Land To Rear Of Springbank, High Street, Stoke Golding, Nuneaton LCC Highways Response Tracker

Pell Frischmann (PF) has produced this tracker setting out and itemising the comments from LCC Highways (**Table 1**) to ensure that all the comments are fully reviewed and addressed appropriately.

Description of Application: Demolition of existing dwelling and erection of 19 dwellings, formation of access and associated works

Appendix 4 – 10145-PEF-XX-XX-D-H-000011B P01 Swept Path Assessment

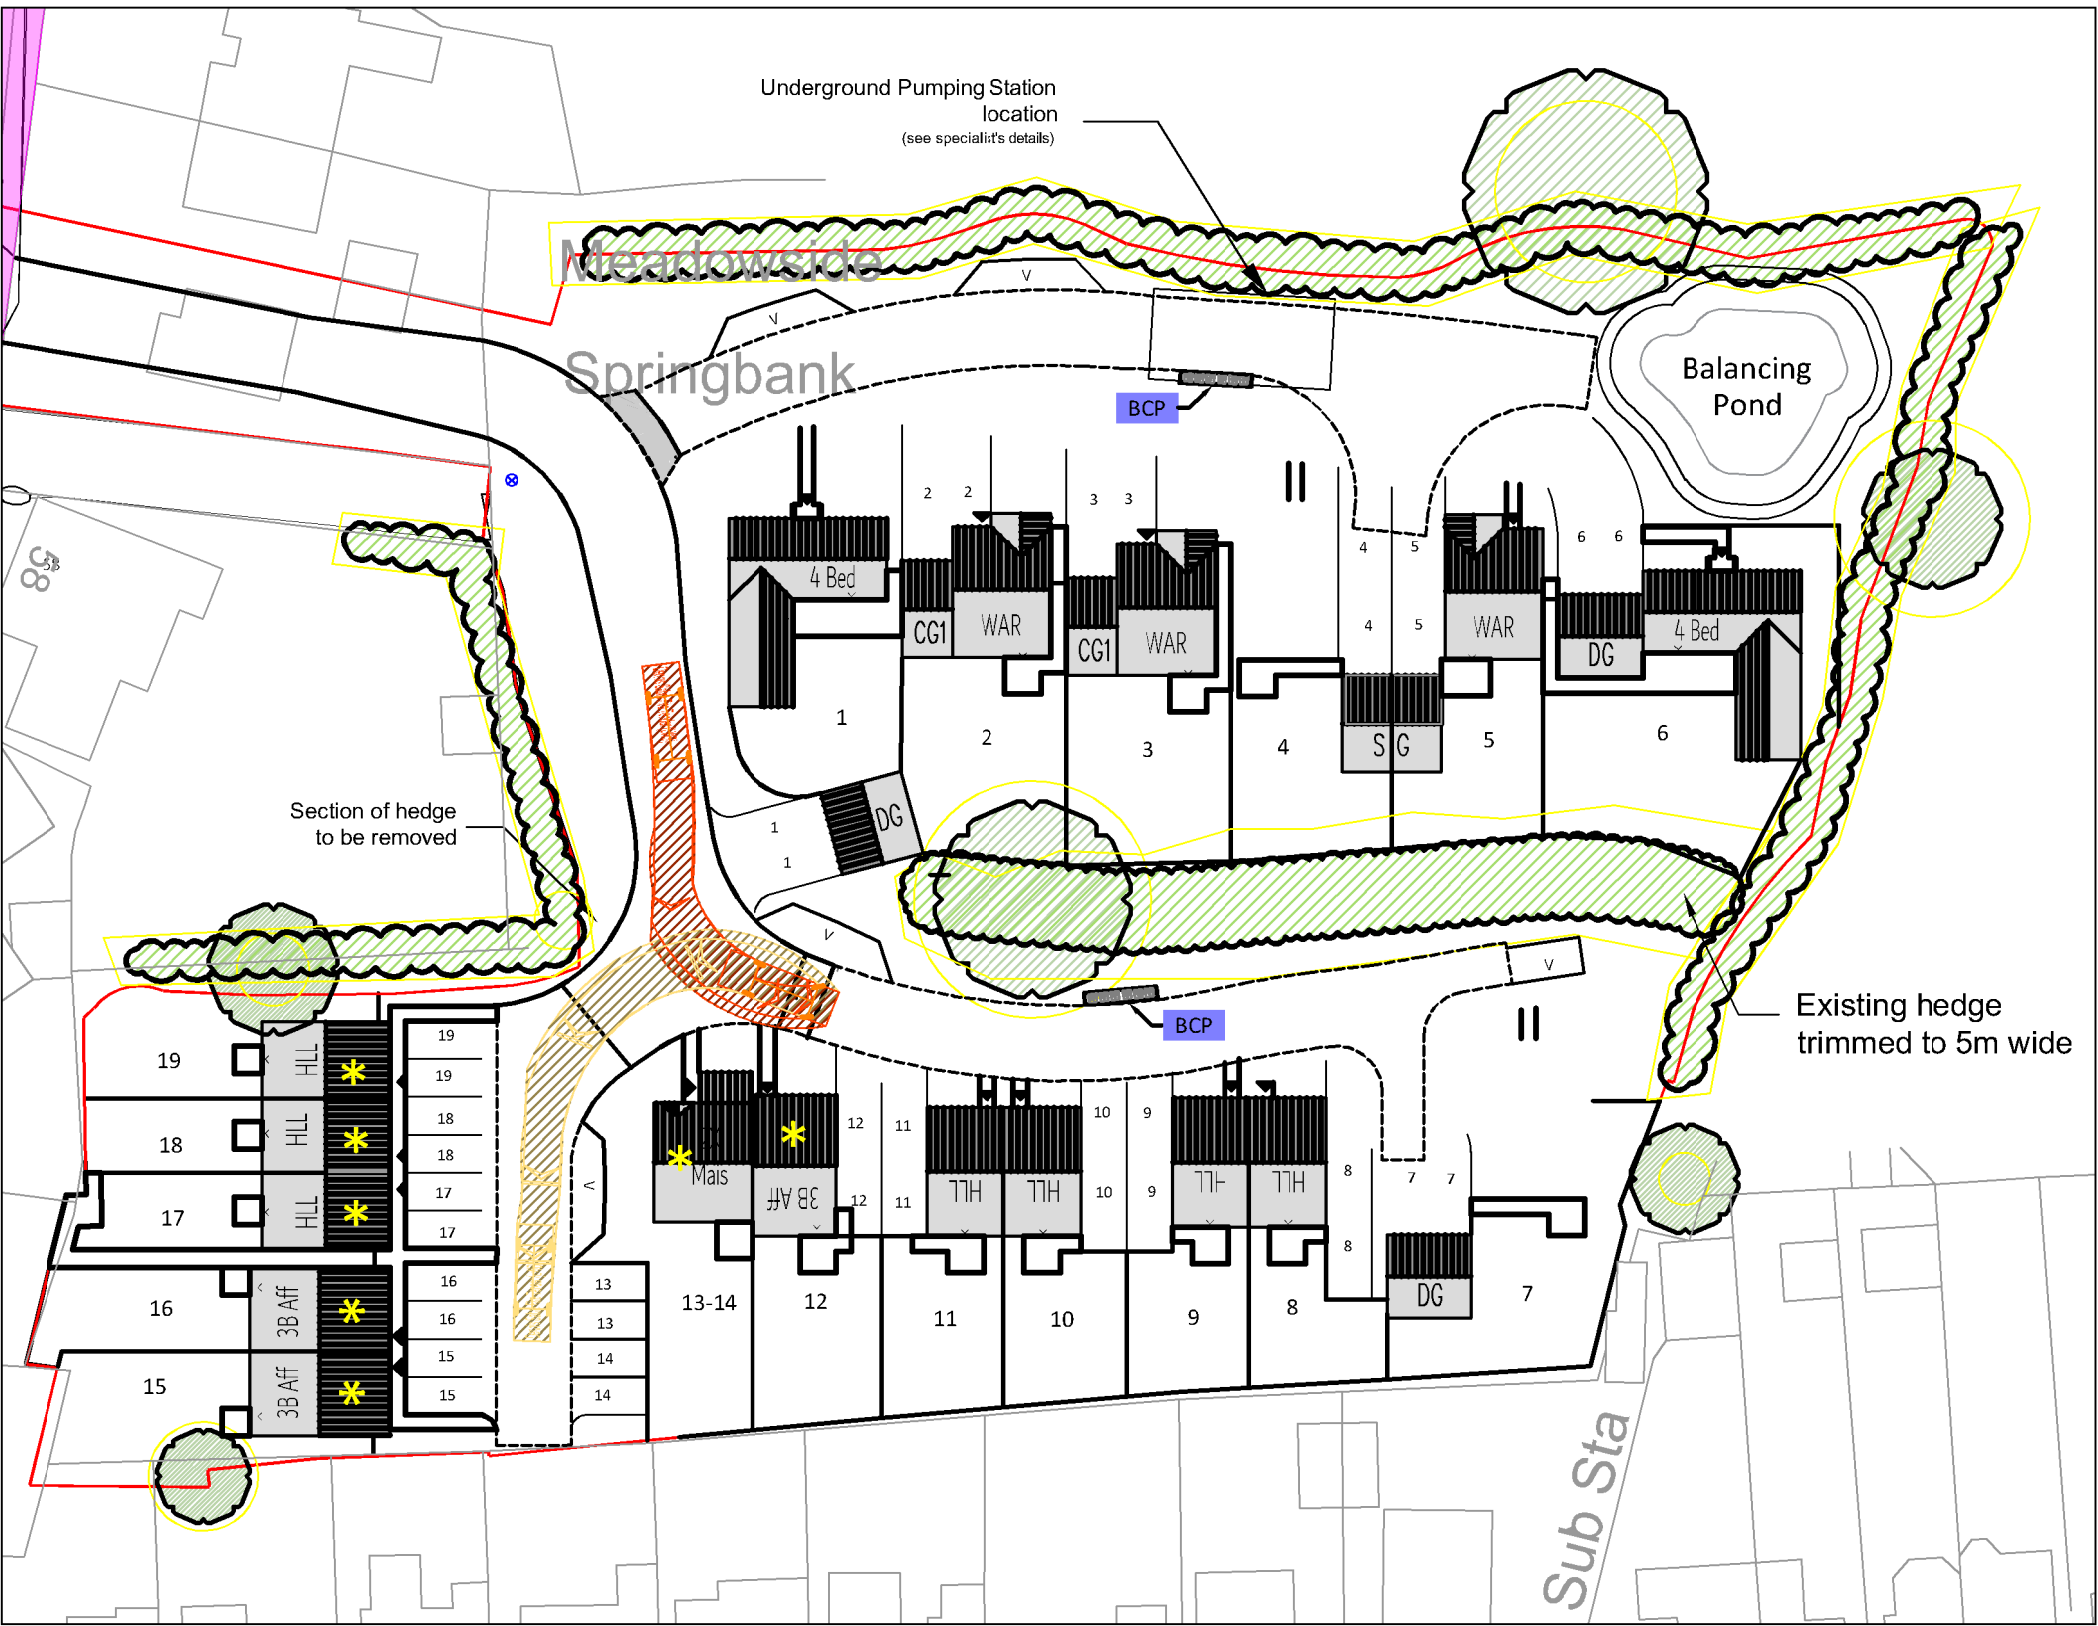
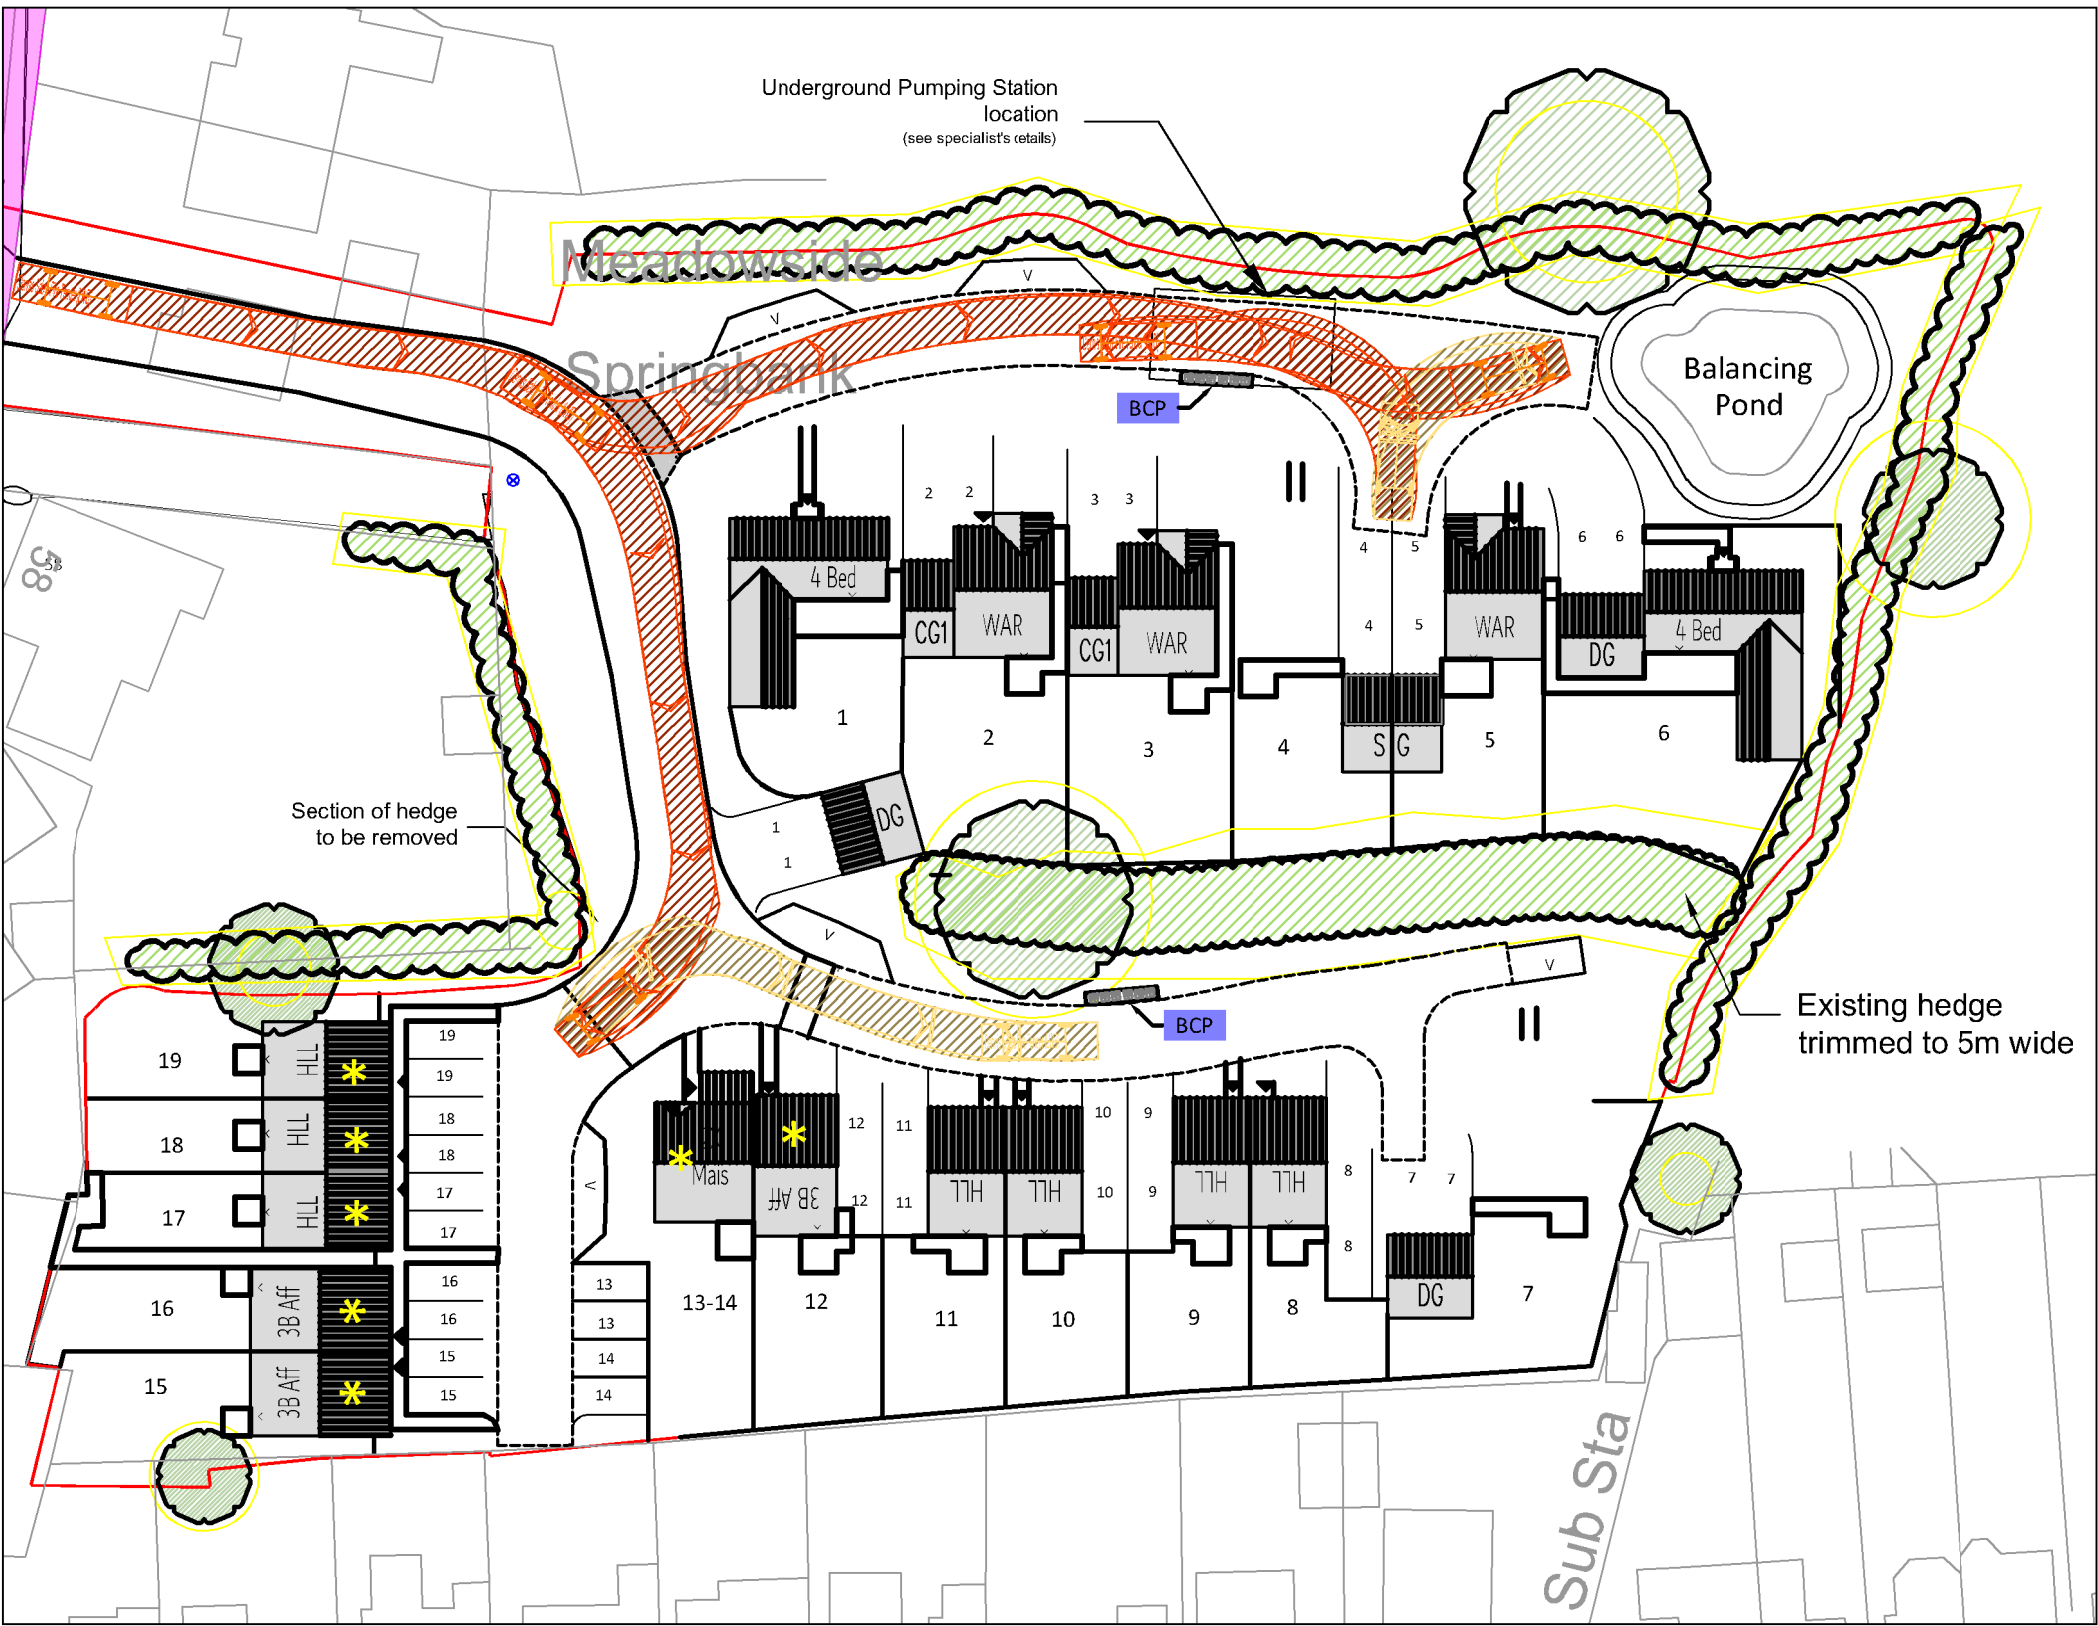
4.	Swept Path Assessment, drawing number 110145-PEF-ZZ-XX-D-H-00006, Rev P01 demonstrates that the proposed access design can accommodate a LCC specified refuse vehicle, which is 11.2m long (Phoenix 2 Duo Recycler (P2-15W with Elite 6x4 chassis) and an DB 32 Fire Appliance measuring 8.6m long entering and exiting the site via the proposed access. The drawing also demonstrates that these vehicles can safely manoeuvre within the site.

Ref.	LCC Comments	PF Response
	• The Applicant should provide refuse vehicle tracking of the site using the attached specification. • There are a few cases of isolated parking in relation to the dwellings, which may result in on-street parking occurring due to poorly positioned spaces. It is suggested parking provision for Plots 1 and 14 is reviewed. The Applicant is advised that the above matters are expected to result in changes to plot positions; should the application be determined with the site layout as currently presented and the Applicant subsequently wishes to put forward the roads for adoption under S38, this could result in the requirement for a Non-Material Amendment or S73 Variation of Condition application being required to be submitted to the LPA to meet the required LHDG standards. The following elements of the proposals do not accord with the LHDG, however, as these are not expected to alter plot positions, it is expected that these can be addressed as part of a future S38 technical appraisal process: • The radii at the junctions and turning heads should be detailed on the plan, to ensure they are in accordance with the LHDG. • The junction radii should be 6m for any side roads. For further information please see Table 9 of the LHDG. • The developer should also note that radii for turning heads should typically be 8m/ 10m. Please see Figure 12 of the LHDG for further information. • The Applicant should remove the visitor parallel parking bays on the road west of plot 1. The Applicant is advised to note the following points: • Grassed 1m service margins are not acceptable, any grass verge areas should be a minimum of 2m in width and be in excess of 10m² in area. • Tactile paved uncontrolled pedestrian crossings should be provided and shown at junctions/where appropriate. e.g. at PROW crossings. • Consideration of root barrier/deflection treatment will be required when proposing trees/shrubs adjacent to the footway. • At this stage it is not possible to comment on the vertical alignment, drainage, materials or proposed construction details.	The revised drawing shows the tracking using a 11.7m long refuse vehicle. - The dimensions and radii are now shown on the revised plans. The internal and site access junctions are private drives serving up to 25 dwellings and therefore drop kerbs have been proposed in accords with the design standards as set out in Table 13. The revised layout reflects the turning head dimensions as set out in Figures 11 and 17. The parallel visitor parking has been relocated. This has been considered and tactile paving is not required at the internal junction or the proposed site access junction as these are private drives serving up to 25 dwellings.

Ref.	LCC Comments	PF Response
	Should the Applicant wish the double garages to count towards parking provision, The Applicant will need to amend the measurements to accord with the LHDG specifications. The current measurements would only count towards one parking space within each double garage. Taking this into consideration, plots one, six and seven to which they apply, would have the minimum required parking spaces if the current double garage measurements remain. Swept Path Assessment, drawing number 110145-PEF-ZZ-XX-D-H-00006, Rev P01 states that Plot 7 garage and car parking spaces to be relocated. Given this is a full application, the LHA require an updated plan to demonstrate this. Swept Path Assessment, drawing number 110145-PEF-ZZ-XX-D-H-00006, Rev P01 demonstrates that a LCC specified refuse vehicle, which is 11.2m long (Phoenix 2 Duo Recycler) and an DB 32 Fire Appliance measuring 8.6m long can safely manoeuvre and turn around within the site via the internal spine road. It also shows that the fire tender can access each dwelling within a distance 45m and does not need to reverse more than 20m.	Updated. Refuse tracking and Fire Tender tracking is acceptable. PF has re-tracked it as a result of the changes to the internal road layout.
